Sub: Corrigendum-01: Amendment to Tender specification document & due date extension

- 1. E-Tender specification No: 2101094
- 2. **Scope of work:** Detailed drawing preparation based on Input design drawings provided by BHEL-Engineering Centers for Flue Gas Desulphurization (FGD) Package as specified in scope and getting approval from BHEL- Engineering Centers/ NTPC. Fabrication and supply of finished product (procurement of raw structural steel will be in the scope of bidder) i.e. structures of FGD as per BOM/Drawings at 2X500 MW NTPC Mauda, Stage-I, TPP-FGD, Maharashtra.

2 X 500 MW MAUDA STPP-FGD PACKAGE			
DWG / DOC NO AND TITLE : 9561-109-ISG-PVC-B-445 - CONVEYOR LBC-1AB-GA OF GALLERY & TRESTLES R0				
SL NO	NTPC COMMENTS	BHEL REPLY		
1	Hold	Staad file has been revised and errors resolved		
2	PTFE bearing shall be provided for slinding support	Accepted. PTFE indicated in elevation view.		
3	COMPLY TO COMMENTS MARKED DESIGN DOCUMENT	Complied		
4	DESIGN/DRAWING TO CONFORM TO LATEST MECHANICAL/ELECTRICAL GADRG.	Accepted. Trestle Tr-2A introduced for structural requirement, after discussion with mechanical. The same will be updated in Mech GA dwg.		
5	ALL FURTHER CHANGES TO BE I

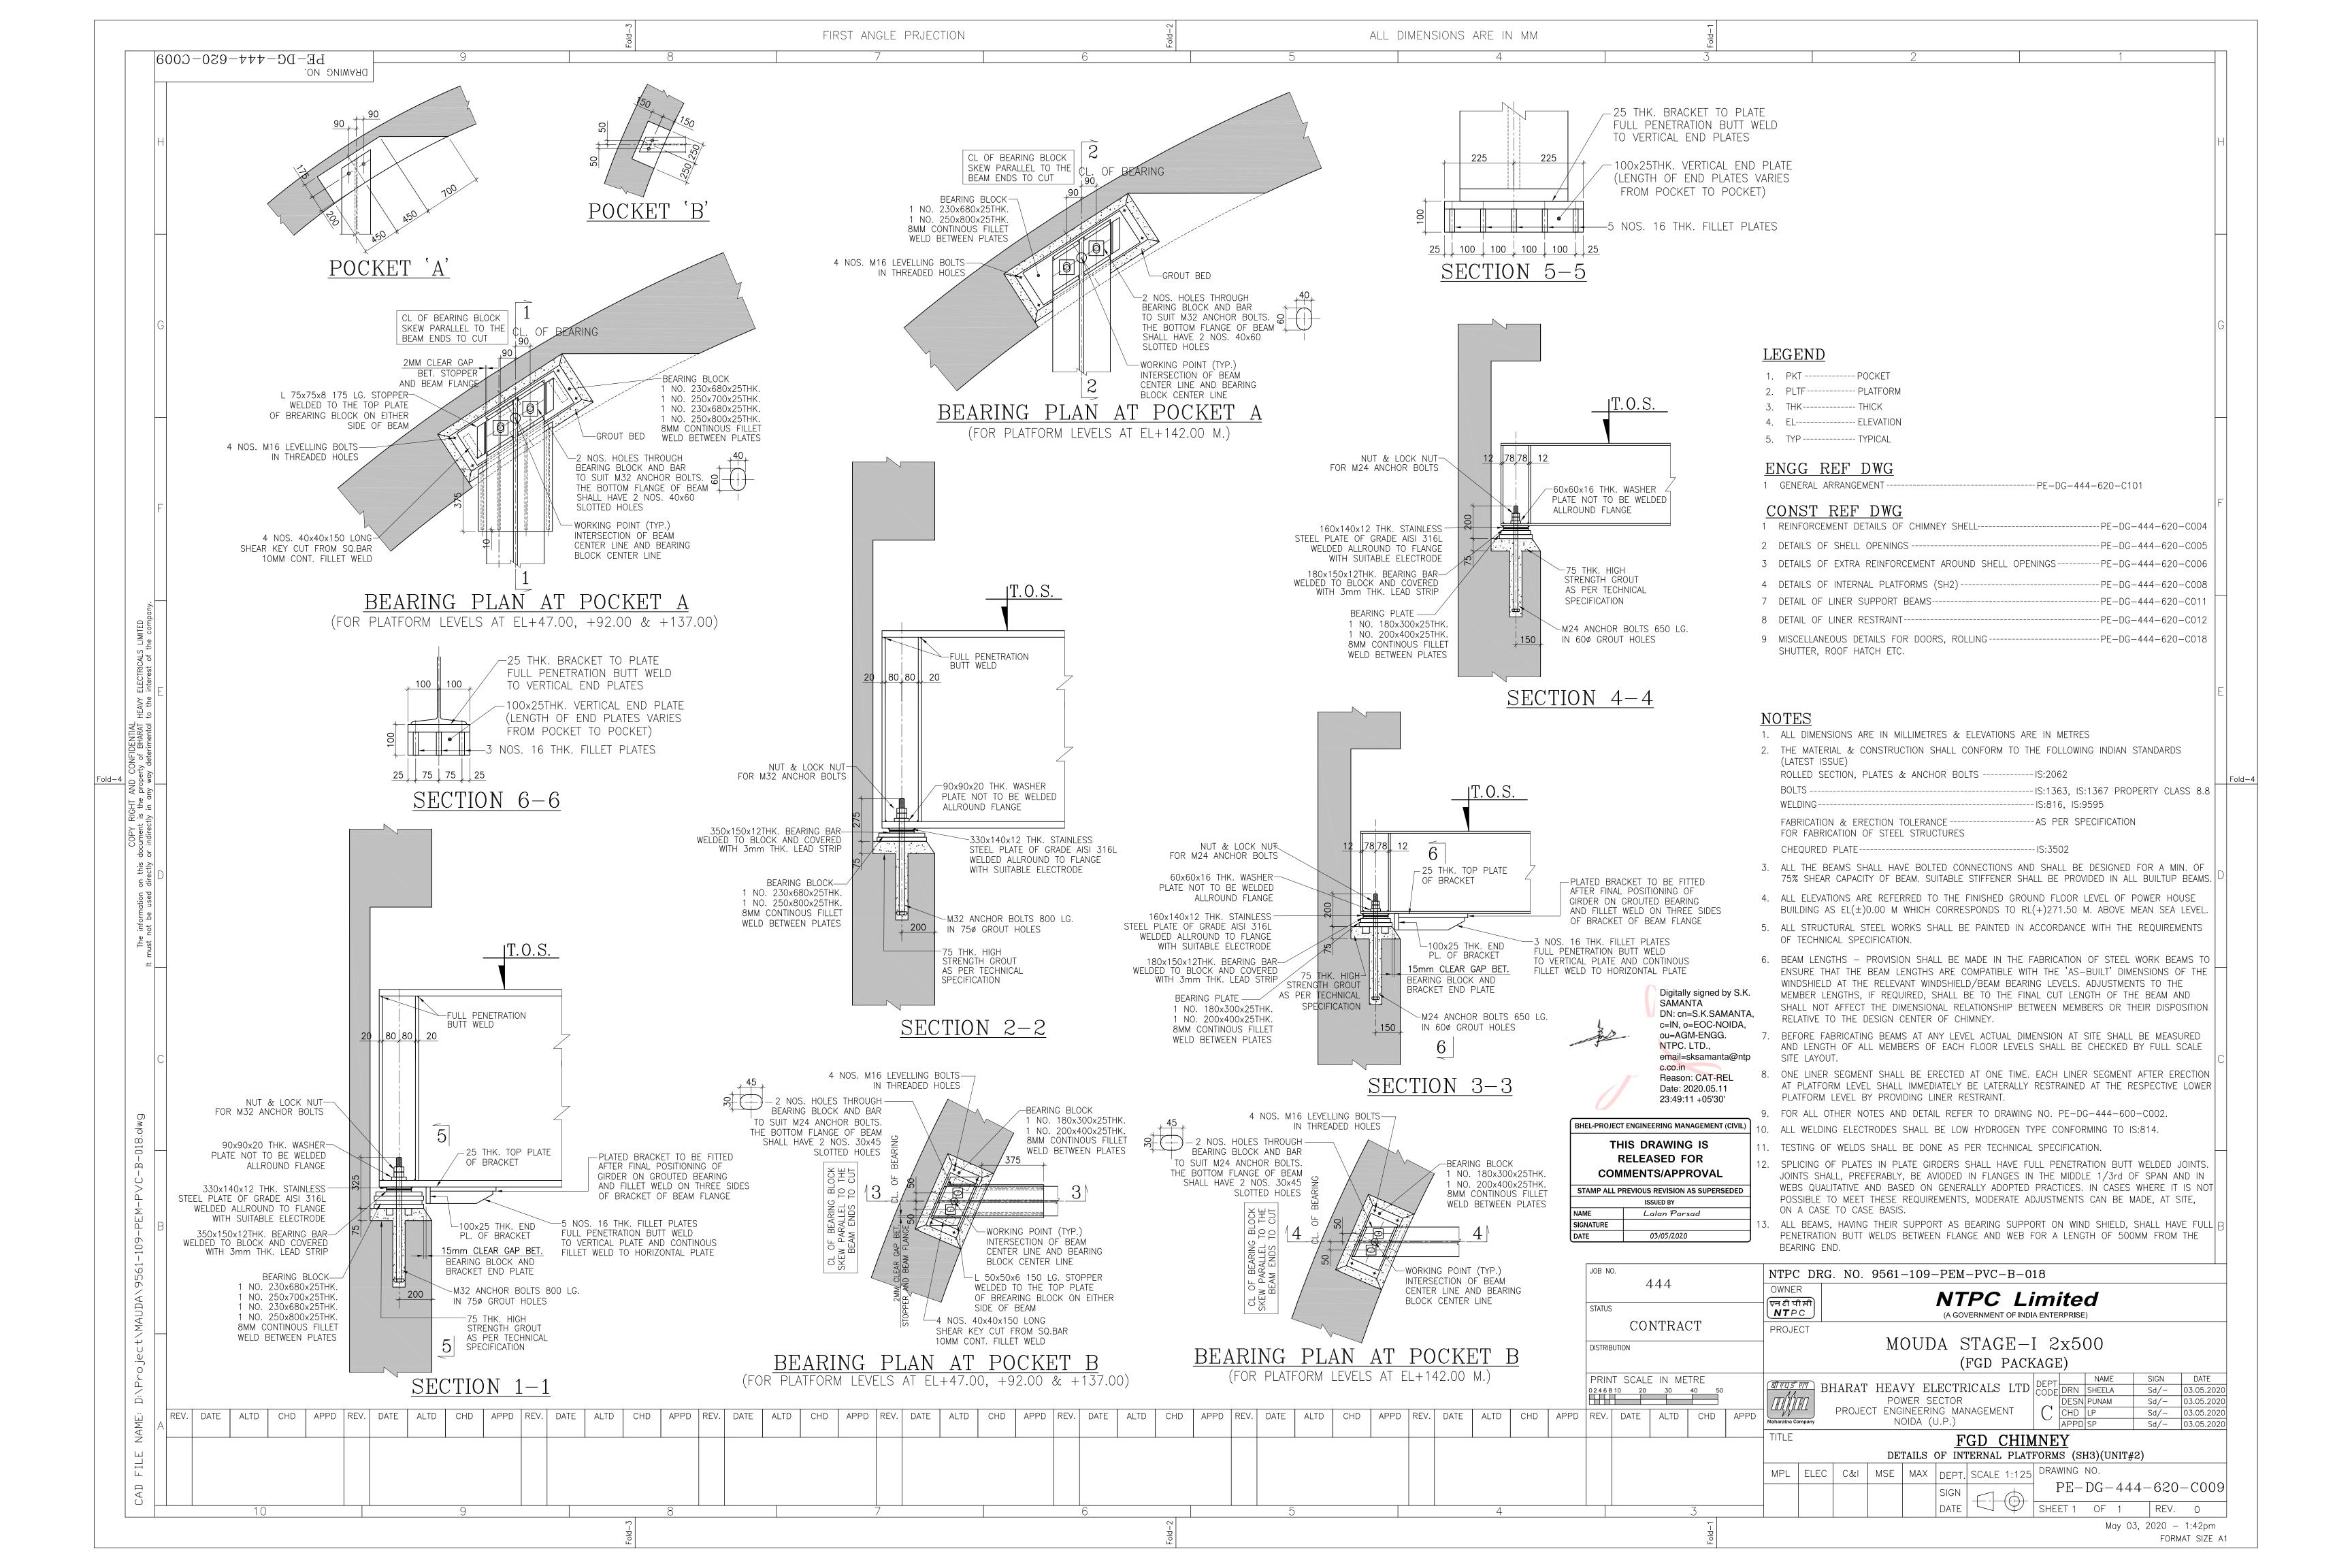
2 X 500 MW MAUDA -STPP PACKAGE			
CI NO	NTPC DWG / DOC NO AND TITLE : 9561-109-ISG-PVC-B-457 - (Gypsum Shed Unit-R1)			
SL NO	NTPC COMMENTS	BHEL REPLY		
1	Remove it as it shall cause hinderance in loading of trucks	As per the approved mech GA, gypsum is stored inside the shed by the tripper / conveyor only. Trucks are not envisaged to load gypsum at EL(+)7.10M. Hence, door for maintenance platform will not pose any threat to service requirements.		
2	these bracings not allowed. This shall create hinderance in truck movement for loading purpose.	As per the approved mech GA, gypsum is stored inside the shed by the tripper / conveyor only. Trucks are not envisaged to load gypsum at EL(+)7.10M. Hence, the side bracings will not hamper service requirements.		
3	please keep design same as mech GA.	Total dimension of the shed is inline with that of the approved mech GA. However, due to introduction of expansion gap in the RCC structure below as per design requirements, grid to grid dimensions at ends of expansion joint are suitably modified.

4	check the ladder support location. This must be for access to hoist maintenance platform. The location to be revised as per mech GA.	These ladder supports are meant to access door maintenance platform. Ladder for Hoist maintenance platform are shown separately in the revised dwgs.		
5	DE system foundation to be as per approved GA of equipment. Further, this is at EL (+) 7.10 M.	As it is a structural dwg, location & detail of DE system foundations are shown for indicative purpose only. For details of the same, kindly refer the relevant civil dwgs.
